Office Action Summary

10/511,070

JONES, STEVEN VICTOR

DETAILED ACTION

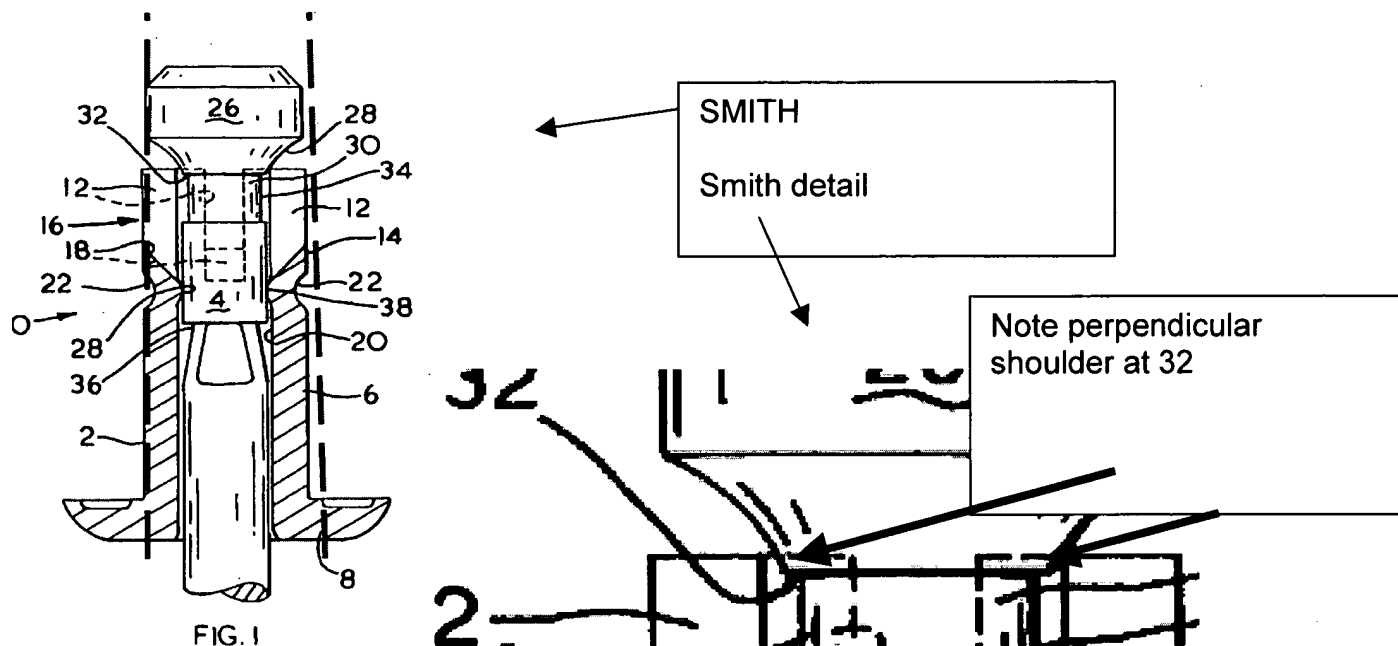
Smith teaches a peel type blind rivet with an elongate tubular body 2 having a shank 6 and preformed head 8 at a first end and expandable portion 16 at opposed end remote from head. The expandable portion comprises a plurality of slots 12 terminating remote from 1st end. The tubular body defines a mandrel accepting bore or aperture of constant internal diameter (ID) –the respective sections of the body on either side of projection 24 (note that “24” is mislabeled as “28” in the Figures, but should be the projection formed by groove 22 displacing inward) can each be considered a mandrel accepting bore of constant ID, and the respective outer surfaces of each portion can be considered surfaces of constant external diameter. There is a mandrel 4 with head 26

and stem (30,4, Fig 2). The head 26 has a shoulder portion (area of head above "26" extending to include surface "32" is all considered the shoulder – that is, the shoulder is the tapered portion at "28' AND the portion 32 perpendicular to said mandrel stem (Fig 1 below), wherein the shoulder portion is in contact with the opposed end (portion of shoulder at 28 is in contact with opposed end per blown up detail below) AND the shoulder 28/32 also defines a bearing surface (the portion at 32 is the defined bearing surface that is substantially perpendicular to the stem). The maximum head diameter is greater than the ID of the body (page 5 lines 9-11). The said stem has a first cylindrical portion (at 30, Fig 2) adjacent the head having a first generally constant diameter and a second cylindrical portion (at 4, Fig 2) having a second constant diameter greater than the first constant diameter.

Further Re 19: The mandrel stem extends through and is co-axial with said tubular body (Fig 1). The mandrel has a first portion (at 30) disposed adjacent the shoulder, said 1st portion defining a cylindrical surface having a generally constant diameter.

Re claim 20: Breakneck 36 defines 3 angled surfaces, (see Fig 1 and compare to applicant's "136' in Fig 3).

Re 2,13: The opposed end of the shank presents a flat surface (end of "12") perpendicular to said shank axis in Fig 1.

Re claims 3 and 6, 14 and 17: Looking at the slope of the bottom edge of the groove, identified as 18 in Fig 1, it is clear the slot increases in length as it extends from an outer surface to an inner surface. (see also page 3 lines 7-10 and page 6 lines 1-4)

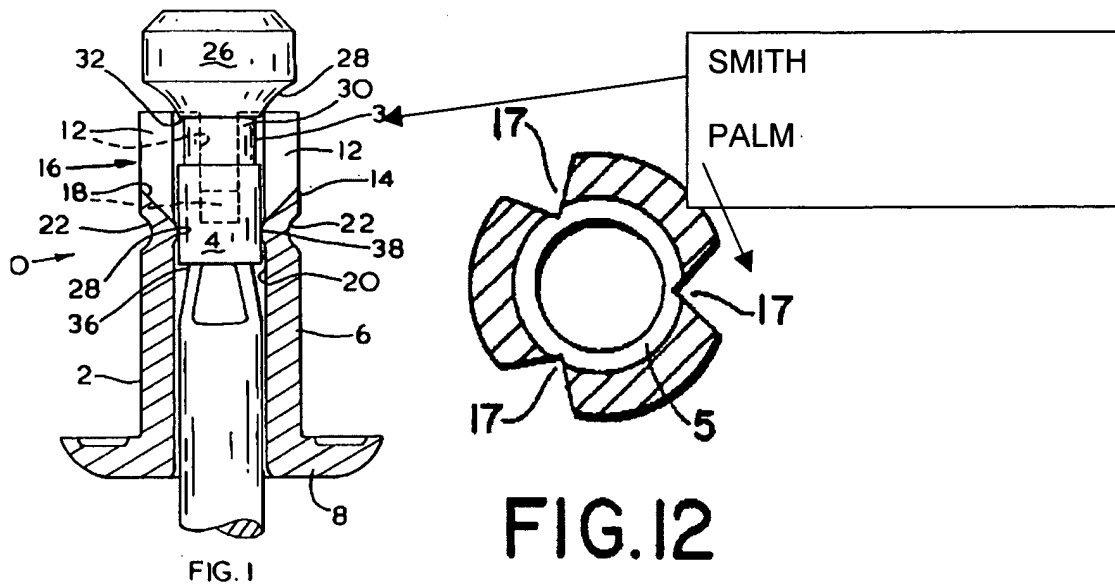
Re claim 7-8,18: Fig 1 shows constant thickness of walls along axial length, and that the external diameter of the body is constant along its axial length

Re claim 10: Fig 1 above shows the maximum diameter of the head equal to the OD of the shank.
